**From:** [redacted]>
**Sent:** 04 April 2025 12:45
**To:** Marie Roseaman <Marie.Roseaman@huntingdonshire.gov.uk>
**Subject:** RE: 25/00225/FUL - GSN Conservatories The Town Great Staughton St Neots PE19 5BE - Extension to existing conservatory showroom building, erection of 6 no. light industrial units (Class E) and associated layout alterations
**Importance:** High

Commentary

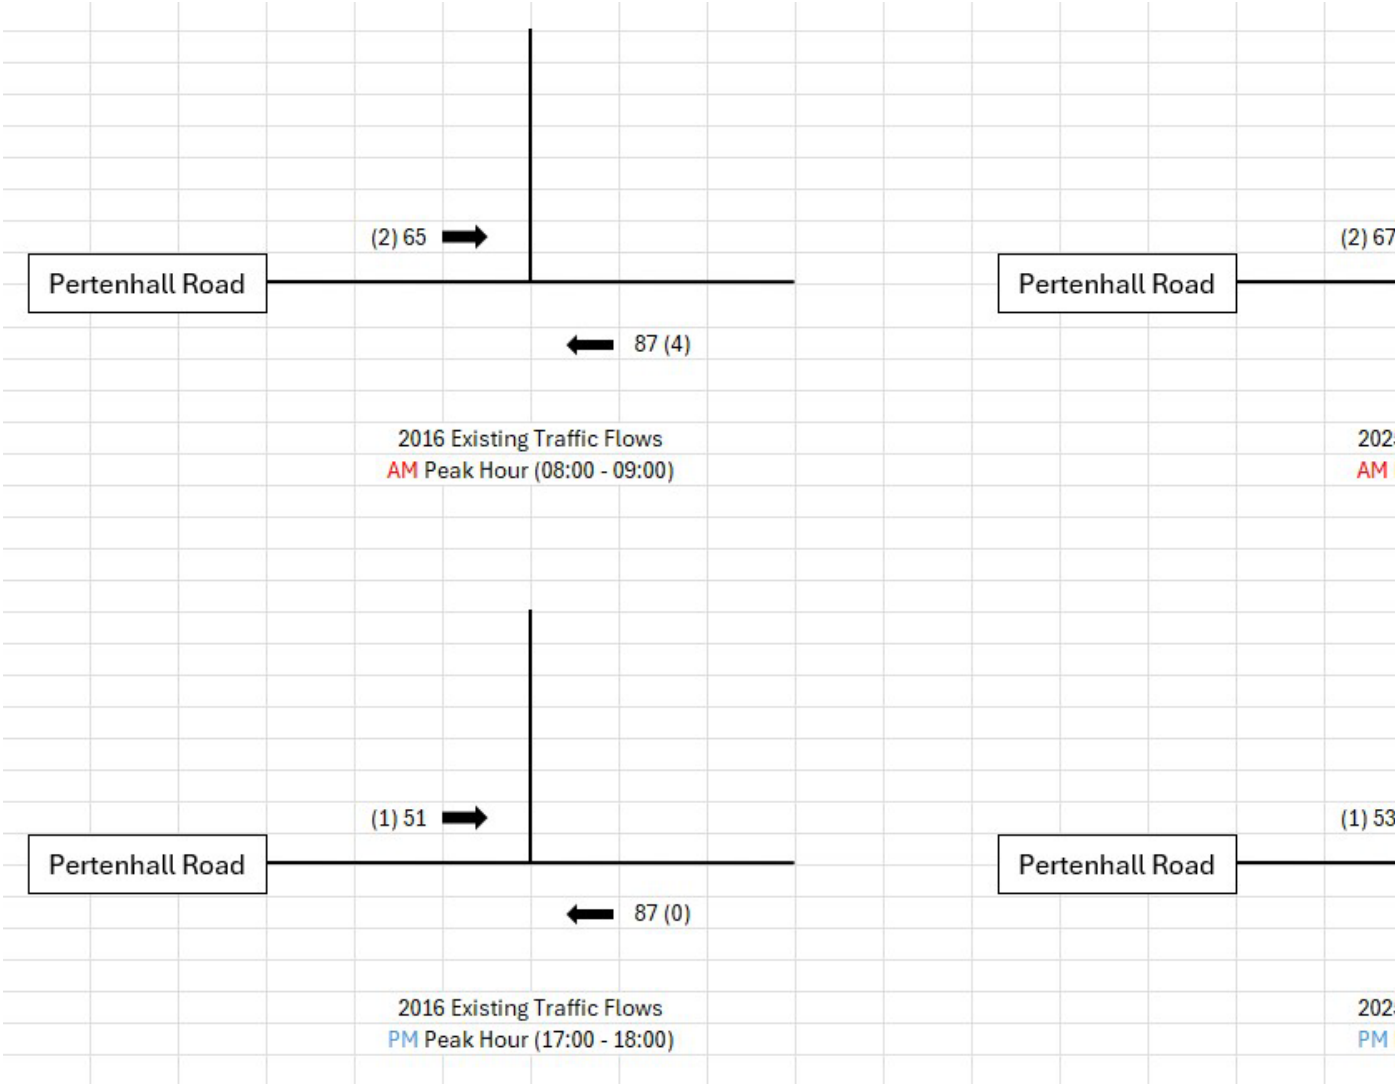
Secondly, CCC have suggested that a traffic survey needs to be undertaken to determine if the number of vehicles to be generated by the development proposals will have an impact on the operation of the local highway network.

The below traffic flow diagrams show the 2016 surveyed and 2025 growthed traffic flows along Pertenhall Road in the vicinity of the application site. The 2016 surveyed flows have been extracted from the Transport Statement (ref: 22601/04-17/4823) prepared in support of development proposals at the Zantra site (ref: 17/00764/FUL). A copy of the traffic survey data from the Transport Statement is attached for ease of reference.

The above traffic flow diagrams identify two-way vehicle movements of 157 and 143 vehicle movements during the AM and PM peak hours, respectively. These peak hour traffic flows are considered very low and the addition of 14 (8.9% increase) and 9 (6.3% increase) additional two-way vehicle movements during the AM and PM peak hours, respectively will be insignificant when considering the impact on an already lightly trafficked road. As such, the development will not result in an unacceptable impact on highway safety and the residual impact on the road network will not be severe. Therefore, the development proposal should not be refused on highways grounds as it satisfies the requirements of paragraph 116 of the National Planning Policy Framework.
